CITY OF DALLAS
CITY PLAN COMMISSION
Thursday, May 7, 2015
AGENDA

Subdivision Docket

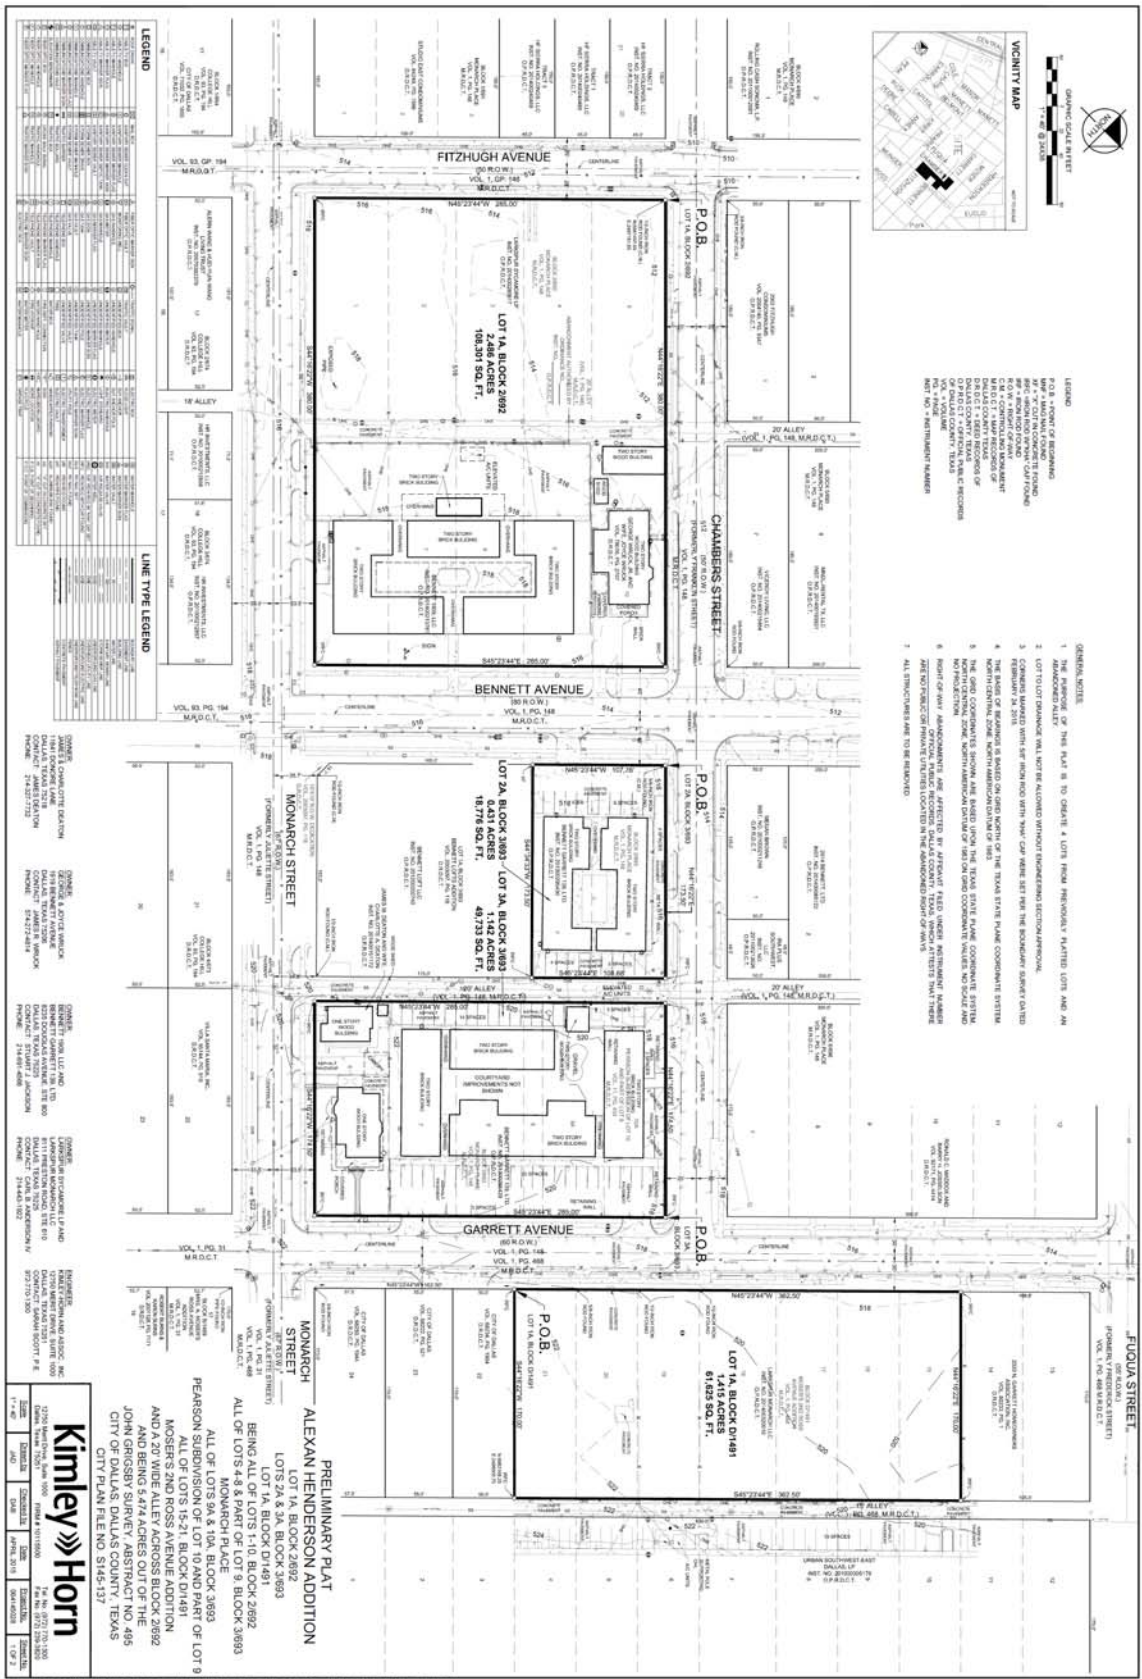
20. On the final plat, correct the Volume and Page of Monarch Place.
21. The number and location of fire hydrants, must comply with the International Fire Code Section 103.1, Appendix C.

26. A release from the Real Estate Division is required prior to submittal of the final plat for the Chairman's signature.
27. On the final plat show the abandonment of the alley as "Abandonment authorized by Ordinance No. _____ and recorded _____. Utility easements retained."

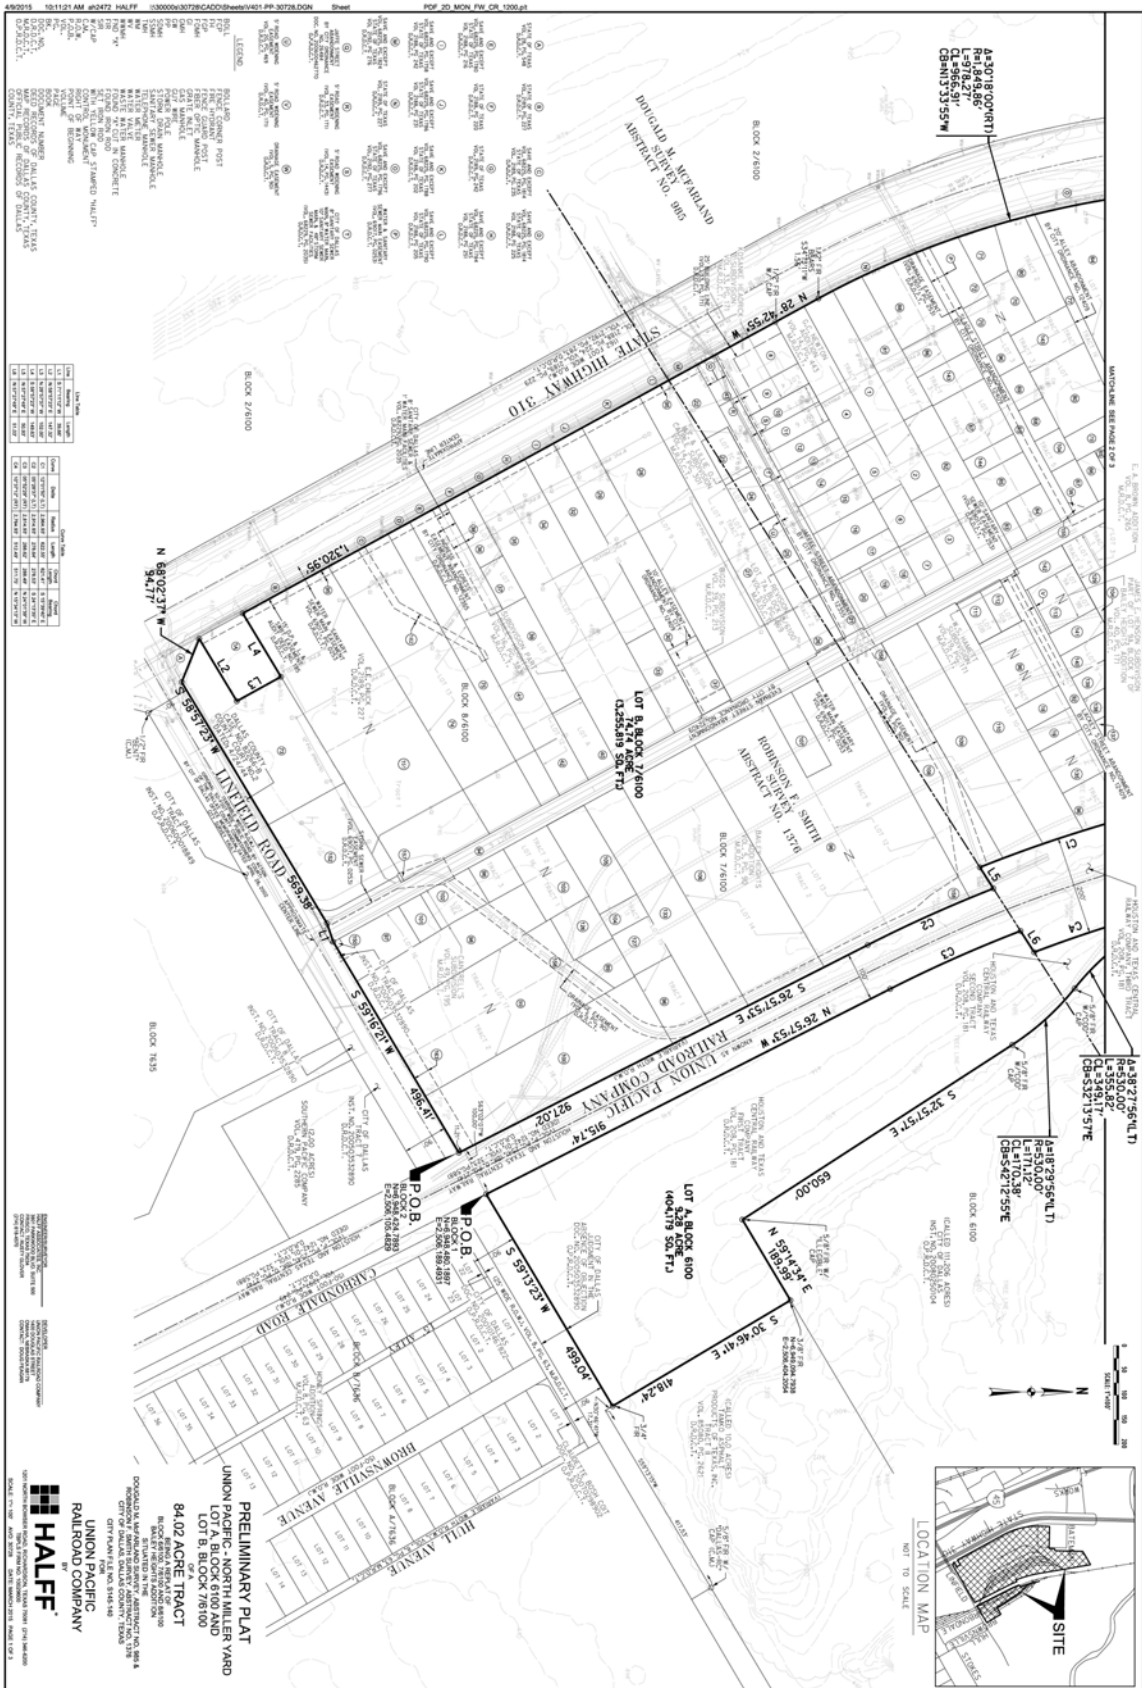
11. Place a note on the final plat "Lot-to-lot drainage is not permitted without Engineering Section approval." Section 51A-8.611(e)
12. On the final plat add note: "TXDOT approval may be required for any driveway modification or new access points on State Highway 310.

32. On the final plat, on both sheets 2 and 3, change "State Highway 310" to "S Central Expressway/State Highway 310". Section 51A-8.403(a)(1)(xiv)(e).
